SERVICE BULLETIN

INSPECTION OF VERTICAL STABILIZER AND TORQUE TUBE AND REPLACEMENT OF ATTACHING HARDWARE

* Supersedes Service Bulletin SB600-030, dated 06 December 2000. This revision changes aircraft affected, the expandable diameter bolt part number and revises accomplishment instructions to include replacement of torque tube bearing race. Aircraft which have complied with SB600-030 do not meet the intent of this revision.

Figure 1. Torque Tube Inspection and Expandable Diameter Bolt Installation

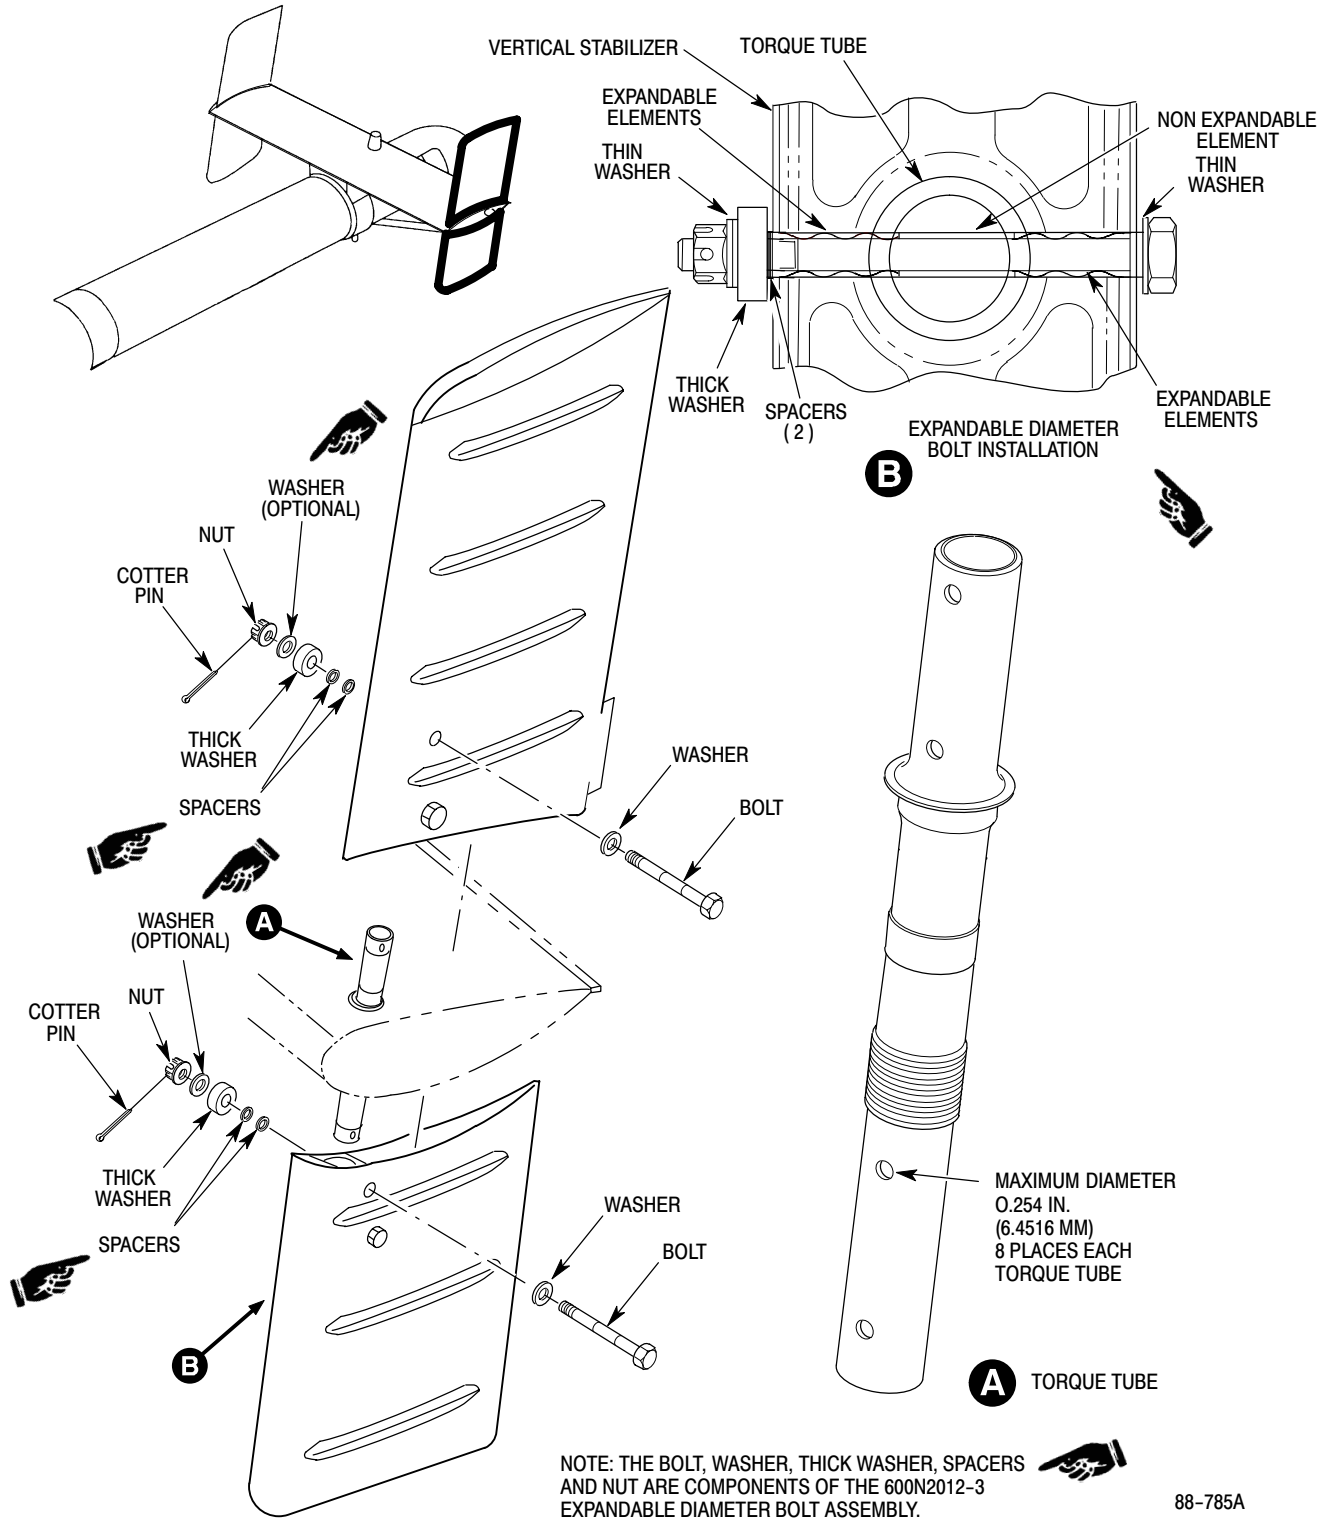
- (1). Check both vertical stabilizers for looseness. Hold either upper or lower vertical stabilizer and move other portion of stabilizer.

- (a). If movement is 2° or less, as indicated on horizontal stabilizer degree plate, inspection is complete. Reinspect vertical stabilizers at each 100 hours of helicopter operation. Removal of existing attaching hardware and installation of expandable diameter bolts removes the 100 hour reinspection requirement.

- (b). If movement is greater than 2°, as indicated on horizontal stabilizer degree plate, check torque of each vertical stabilizer attaching nut.
- (2). Torque check of MS21042L4 nut (if stabilizer looseness is greater than 2°).

- (a). If torque is **40 - 60 inch-pounds (4.52 - 6.77 Nm)**, inspect torque tubes per step B. below.
 - (b). If torque is less than **40 - 60 inch-pounds (4.52 - 6.77 Nm)**, retorque nuts.

- 1). Remove vertical stabilizer attaching nuts.
 - 2). Reinstall nuts and note drag torque.
 - 3). Torque each nut to **30 - 40 inch-pounds (3.39 - 4.52 Nm)** plus drag torque.

- 4). Recheck both vertical stabilizers for looseness. Hold either upper or lower vertical stabilizer and move other portion of stabilizer.
 - a). If movement is 2° or less, as indicated on horizontal stabilizer degree plate, inspection is complete. Reinspect vertical stabilizers at each 100 hours of helicopter operation. Removal of existing attaching hardware and installation of expandable diameter bolts removes the 100 hour reinspection requirement.

- b). If movement is greater than 2°, as indicated on horizontal stabilizer degree plate, inspect torque tubes per step B. below.

- (1). Remove vertical stabilizers (CSP-HMI-2, Section 53-50-30, Vertical Upper and Lower Stabilizer Removal).
- (2). Measure diameter of eight holes in each torque tube.

- (3). If diameter of any hole exceeds 0.254 in. (6.4516 mm), remove and replace torque tube with new parts.
 - (a). Install new bearing race on new torque tube (CSP-HMI-2, Section 53-50-30, Vertical Stabilizer Torque Tube Bearing Race Replacement).

- (b). Remove existing torque tube and install new torque tube with bearing race (CSP-HMI-2, Section 53-50-30, Vertical Torque Tube Replacement).
- (4). If new torque tube is installed, rig vertical stabilizers (CSP-HMI-2, Section 67-20-30, Vertical Stabilizer Assembly Rigging).

- (5). Install vertical stabilizers with existing attaching hardware or with expandable diameter bolts (CSP-HMI-2, Section 53-50-30, Vertical Upper and Lower Stabilizer Installation). If existing attaching parts are used, reinspect vertical stabilizers at each 100 hours of helicopter operation. Installation of vertical stabilizers with expandable diameter bolts removes the 100 hour reinspection requirement.
